Re: ESC Plan for Carlisle Blvd. & Menaul Blvd. Commercial Development Subdivision, 3535
Menaul Blvd NE - H16E083F - NMR1007QA - (SWQ-2026-00012)

E2RC thanks you for your correspondence and comments regarding the Carlisle Blvd. & Menaul Blvd. Commercial Development Subdivision project. This letter responds to each comment in your letter.

TEMPORARY SEDIMENT AND EROSION CONTROL DRAWINGS

CARLISLE BLVD. & MENAUL BLVD.
COMMERCIAL DEVELOPMENT
COA STANDARD ESC NOTES

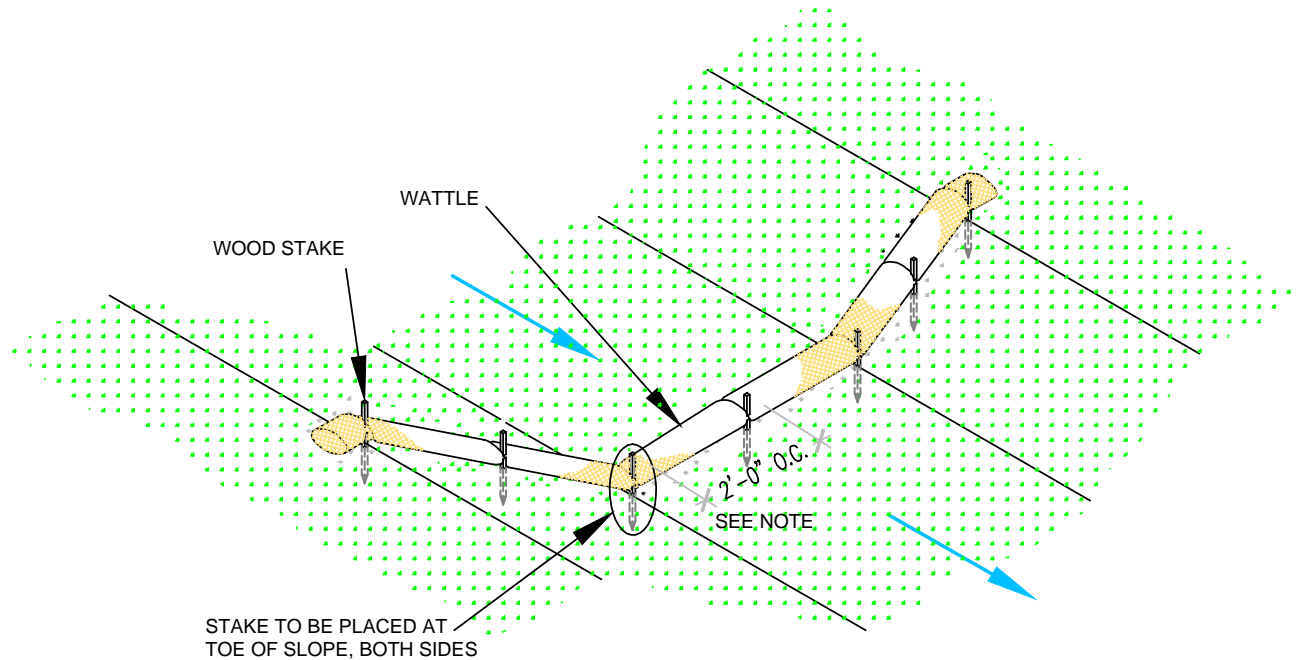
4. Page 4 reflects the February 2, 2026, City of Albuquerque (COA) standard ESC notes and notes that the COA BMP details referenced are still in 'draft' status as of the engineer's stamp date. However, we did not replace the BMP details included in the first submittal, as the BMP specifications developed by the COA are open to comment and change.

We acknowledge COA is developing and has published a draft version of a future standard on the COA website. We also acknowledge other service providers have chosen to incorporate the draft BMP details in current submissions. We believe that is premature due to the possibility of changes before finalization.

Additionally, the silt fence presently installed was completed under the first submittal which was accepted by COA. Is it COA's expectation that the Operator will remove and replace the silt fence to satisfy a draft BMP detail?

**CARLISLE AND MENAUL COMMERCIAL DEVELOPMENT
 BACKBONE INFRASTRUCTURE
 PROPOSED DMP**

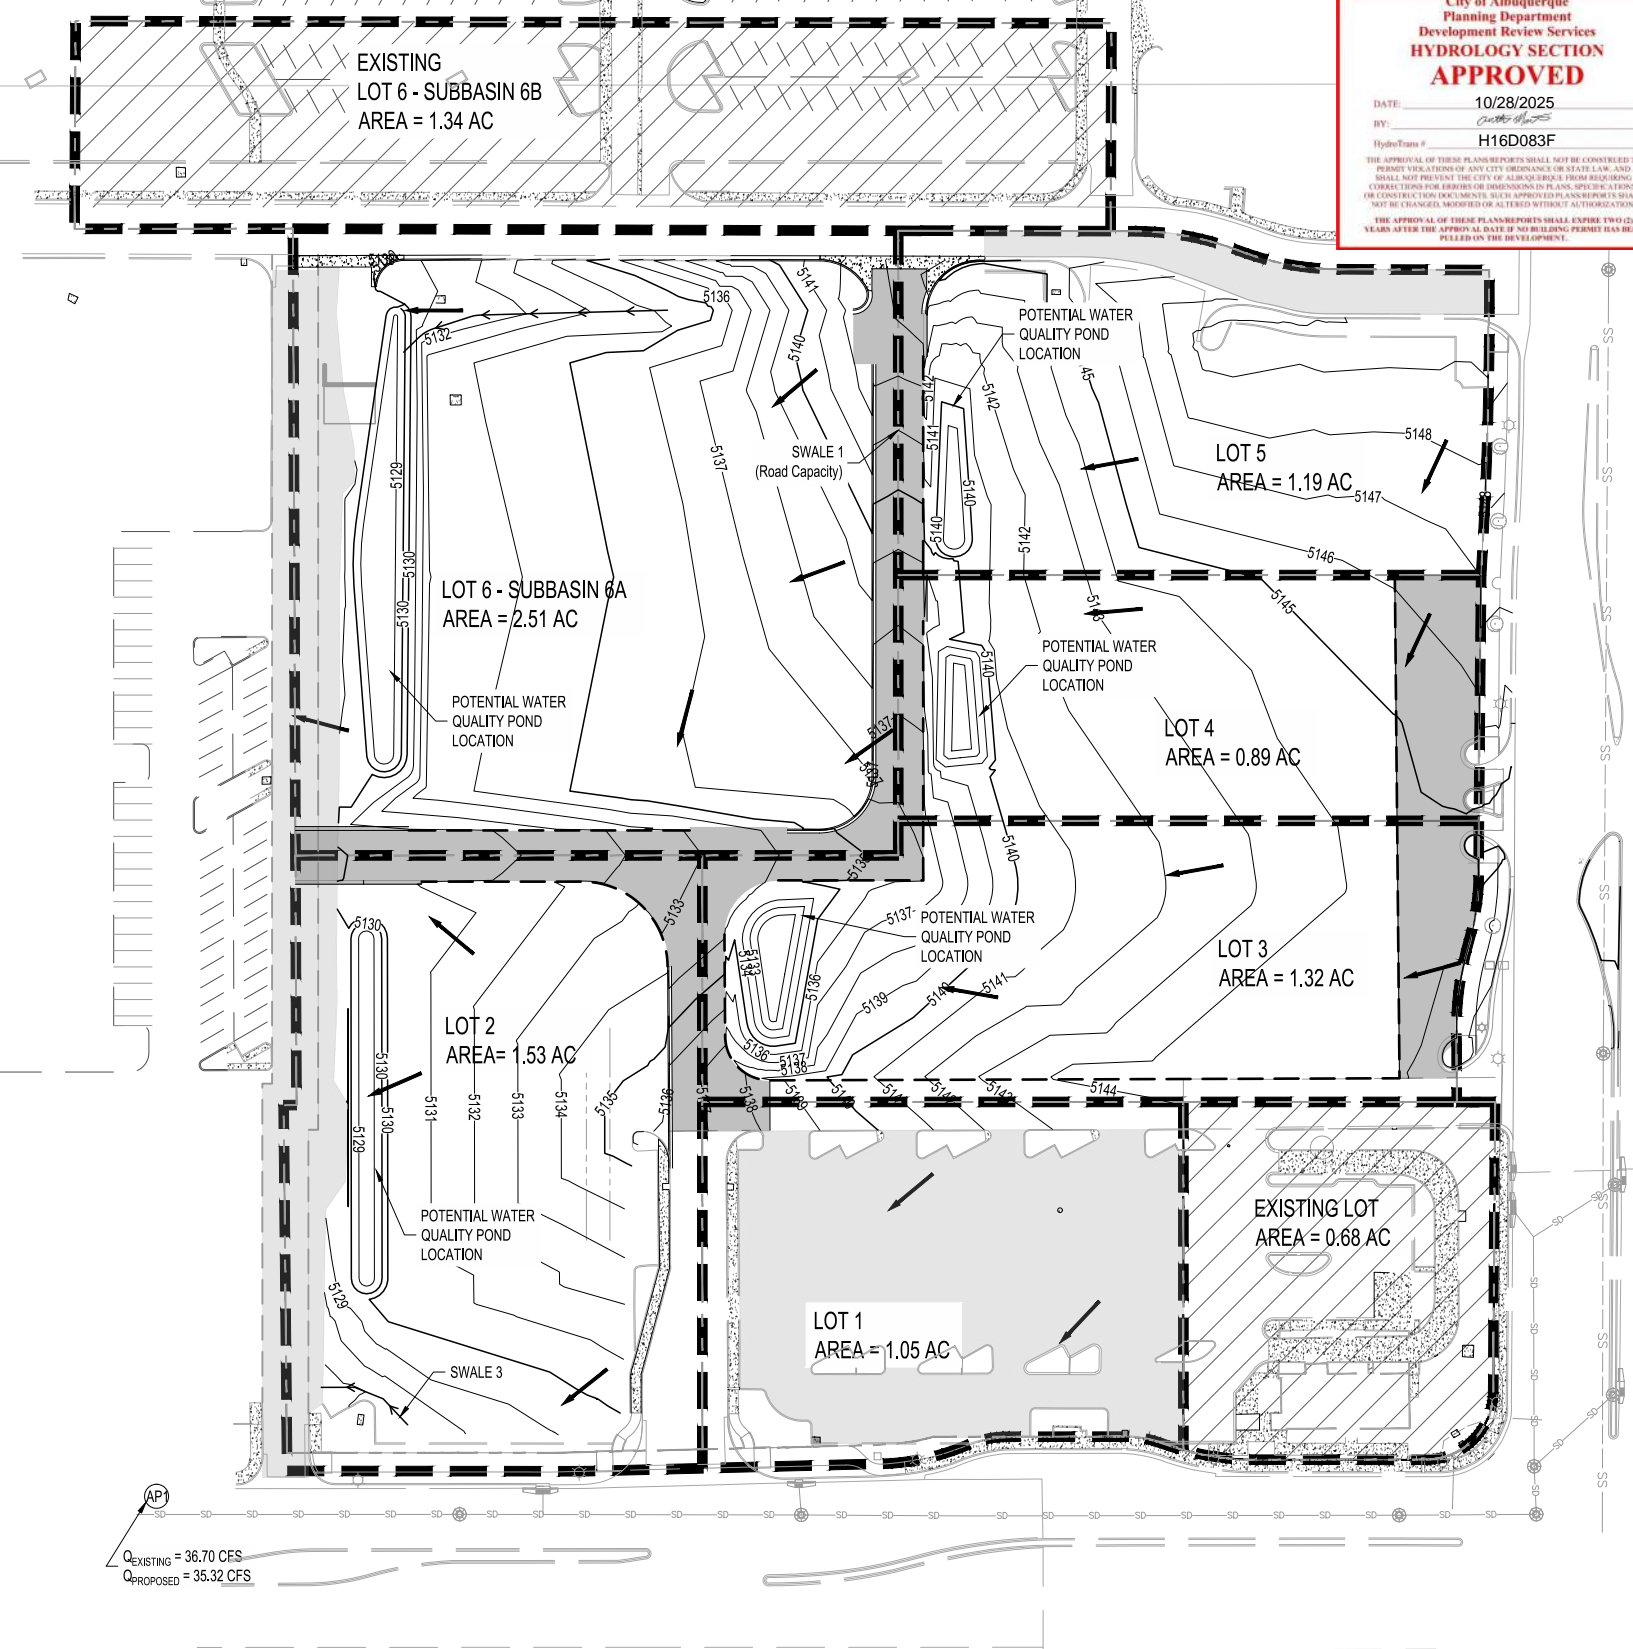
6. The label on Sheet 9 specifies the TESCP is for Phase II. We added a diversion swale on the south side of lots 2-B-3 and 2-B-2 to prevent drainage into the streets on Sheets 9 and 10. Diversion channels to prevent cross-lot drainage should be executed by the prospective buyers' prior to construction as part of the individual lot ESC plans. The *Temporary Diversion Channel* detail drafted by COA is still 'draft' and open to both comment and change. The earthen swale installation detail which was approved by COA Hydrology as part of the *Overall Grading Plan* is included on Page 9.
